Memorandum

To: Seascope Homes LLC c/o Jon Tellefson
CC: Sturman Architects c/o Kati Eitzman
Site: 5222 Forest Ave SE, Mercer Island, WA 98040
Re: Exploratory Pneumatic Excavation
Date: June 20, 2024
Project Arborist: Connor McDermott
ISA Certified Arborist PN-8704A
ISA Qualified Tree Risk Assessor
John Wells
Arborist Technician
Referenced Documents: Site Plan A1.1 (Sturman Architects, 05/14/2024)

Figure 1. Snip of the provided site plan (Site Plan A1.1, Sturman Architects, 05/14/2024). The approximate location of the excavation performed is indicated by the red line.

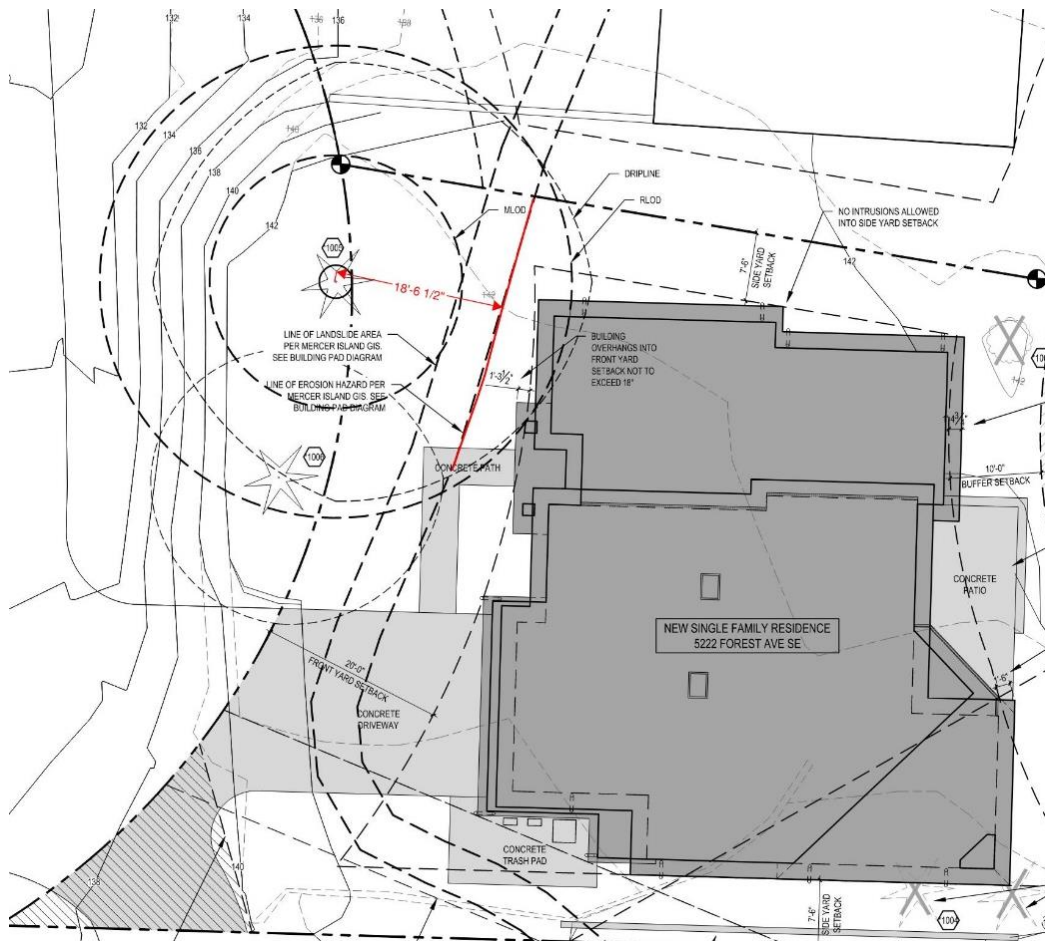
This memorandum documents the site visit of Connor McDermott and John Wells, of Tree Solutions Inc., to the above referenced site on June 14, 2024. We were asked to visit the site and perform exploratory pneumatic excavation at the proposed limits of disturbance for tree 1005 in preparation for a site development. We were asked to provide a memo with our findings and evaluation of proposed impacts. This memo only includes the tree within the immediate construction area as delineated on site plan specifically referenced in this memo (Figure 1).

In our professional opinion, the proposed disturbance will have a minimal impact to the health and structural condition of the tree. We recommend tree protection measures in accordance to Mercer Island Municipal Code 19.10.080, including tree protection fencing, are set at the proposed limits of disturbance.

Photo 1. Tree 1005 indicated above. The proposed limits of disturbance, and where we trenched, is indicated by the orange staking.

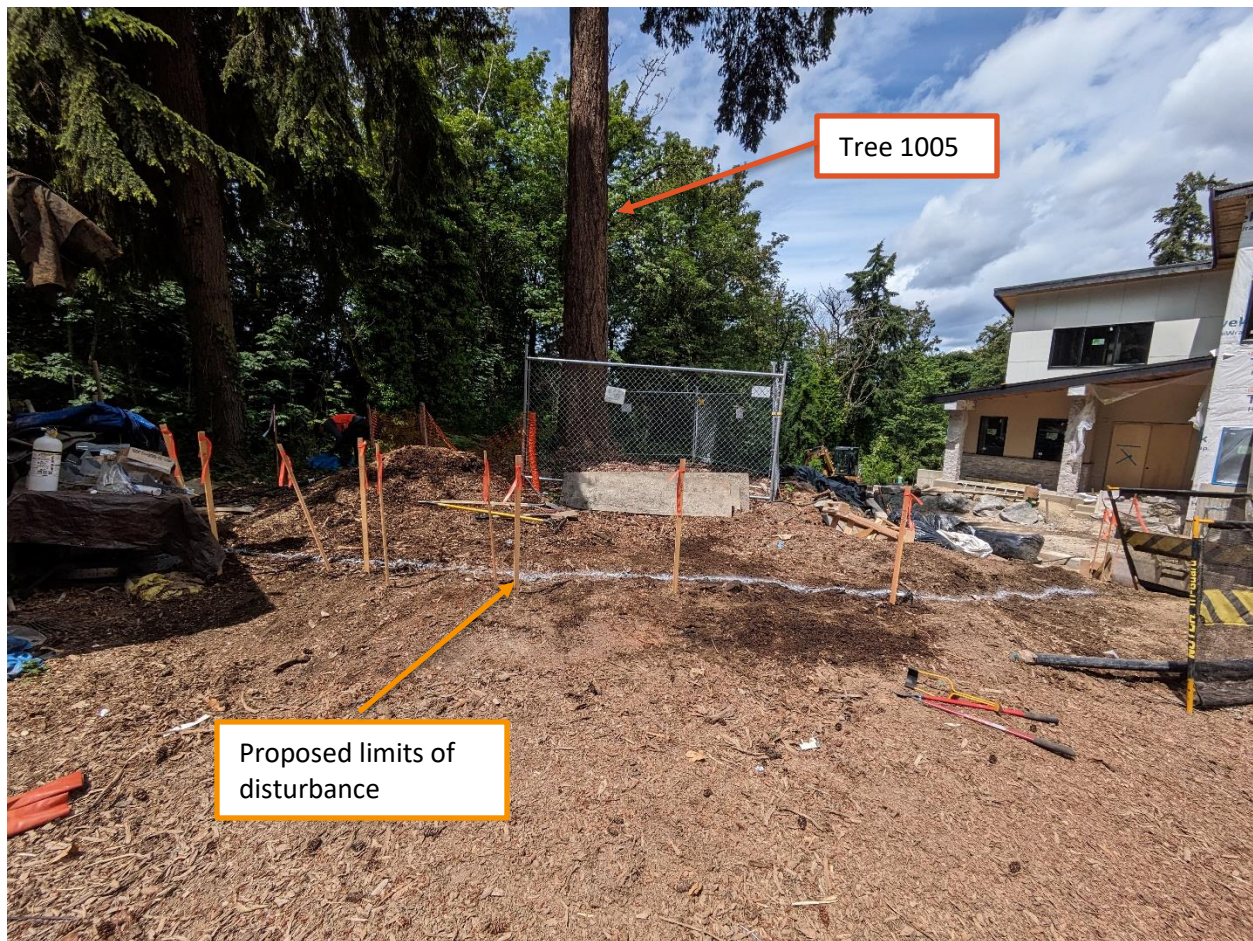
We utilized staking by the contractor, Jon Tellefson of Seascope Homes LLC, to determine the proposed limits of disturbance adjacent to the tree (Photo 1). We excavated an approximately 30 foot long trench 19 feet east of tree 1005 to a depth of 24 inches (Photo 2). We exposed no structural roots, roots over 2-inches diameter, during out excavation and exposed minimal fine roots (Photo 3). Photos documenting our excavation can be found in Appendix B.
